2. AMENDMENT/MODIFICATION NO. <p style="text-align: center;">2</p>	3. EFFECTIVE DATE <p style="text-align: center;">27-Aug-2004</p>	4. REQUISITION/PURCHASE REQ. NO.	5. PROJECT NO. <i>(If applicable)</i>
6. ISSUED BY <p style="text-align: center;">US Army Corps of Engineers, Kansas City District 760 Federal Building, 601 East 12th Street Kansas City, Missouri 64106-2896</p>		7. ADMINISTERED BY <i>(If other than item 6)</i>

Airfield Improvements, McConnell Air Force Base, Kansas

The SOLICITATION is amended as follows:

SHEET 1A

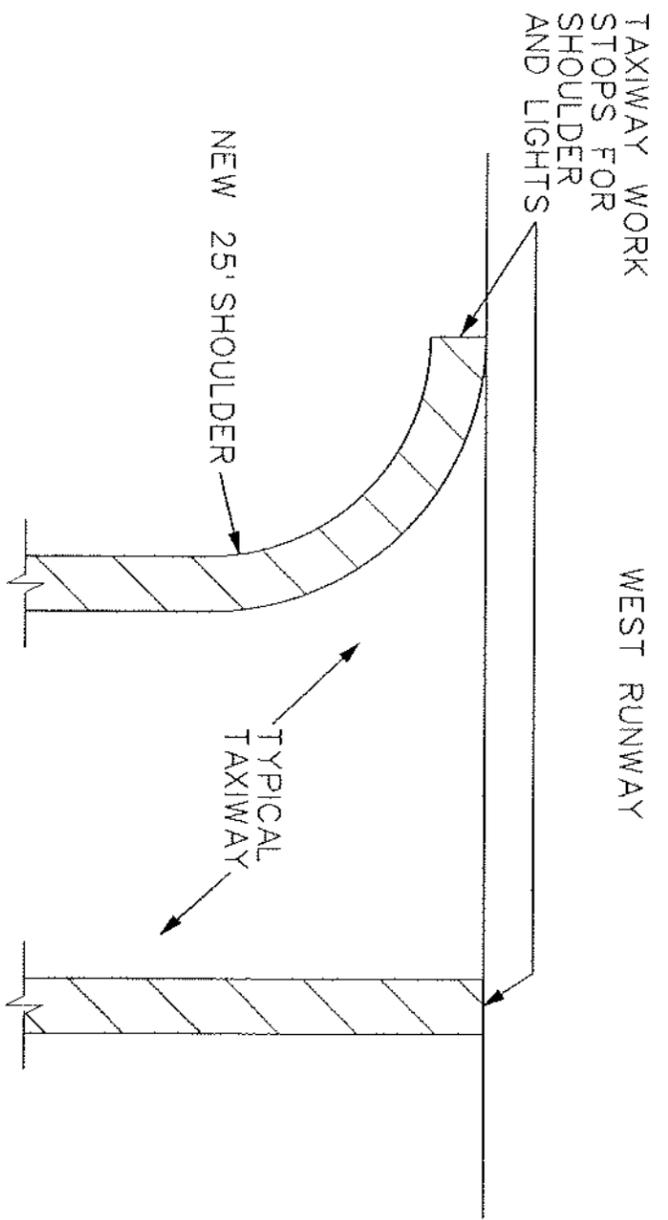
- a. Clarification: Delete all work associated with West Runway lights and shoulders except for the lights and shoulders associated with Taxiways Bravo, Charlie, Delta and Echo (See drawings 4 through 86). The work for these taxiways shall stop at the point of intersection with the West Runway (See typical detail sheet 1A). All work associated with West Runway marking and signage shall remain in contract.
- b. Revised Page: Section 16526A, page 14, paragraph 2.4.1, the sentence reading "All Taxiway "A" lights south of Taxiway shall be reused." Is changed to read "All Taxiway "A" lights south of Taxiway Delta shall be reused."

2. DRAWINGS: Attached is a new sheet, Typical Detail 1.A.
